**SUBJECT: LETTER OF SUBSTANTIAL COMPLETION
101 GOLDENROD DRIVEWAY - TUNNEY'S PASTURE
DND DATA CENTRE - BUILDING 16 - FIRE ALARM SYSTEM REPLACEMENT
PWG2332437-CS
GWAL PROJECT NO. 2021-445**

PROJECT NAME	101 GOLDENROD DRIVEWAY - TUNNEY'S PASTURE - DND DATA CENTRE - BUILDING 16 - FIRE ALARM SYSTEM REPLACEMENT - PWG2332437-CS		
CONTRACTOR	WIRED SYNERGY INC.		
PROJECT NO.	GWAL 2021-445		
DATE	MARCH 20, 2024	BUILDING PERMIT NO. 2206386	
FOR NO.	E7/R1	ESA NO. 17588944

Figure 2 - PART B
Item 2.8.3

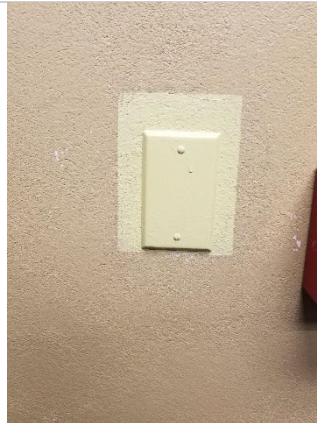
- .1 City walk through of new system and testing of alternate devices with consultant.
- .2 S1001 commissioning report completed.
- .3 **Contractor to provide sample of wall patching and get it reviewed and approved by client going forward with installation. Contractor to change all 4 by 4 covers on columns and walls with 6 by 6 cover plates or a double gang blank cover plate where applicable. Matching of colours to be reviewed to have a closer match. (Figures 2-6)**

Figure 8 - PART B
Item 1.1.3

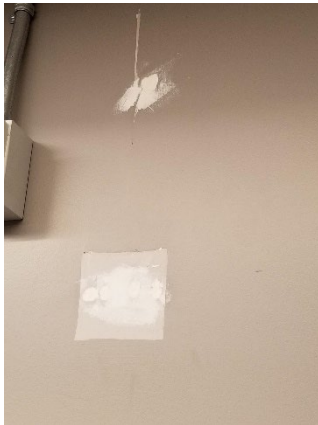
- .1 Removal of wall devices, conduits, and boxes completed.
- .2 Cleaning and patching of walls completed.
- .3 Open box to be closed at ceiling front of room B-10. (Figure 8)
- .4 Room B-76 wall penetration to be completed. (Figure 7)

Figure 9 - PART B
Item 1.4.4

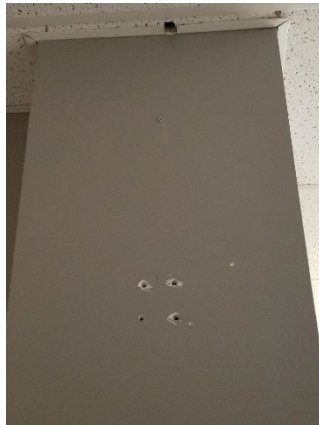
- .1 Removal of wall devices, conduits and boxes completed.
- .2 Cleaning and patching of wall is on-going.
- .3 Repair of floor penetration at stair well reviewed.
- .4 Room 329 - Patching to be painted. (Figure 9)
- .5 Column front of room 324 patch and paint to be completed. (Figure 10)
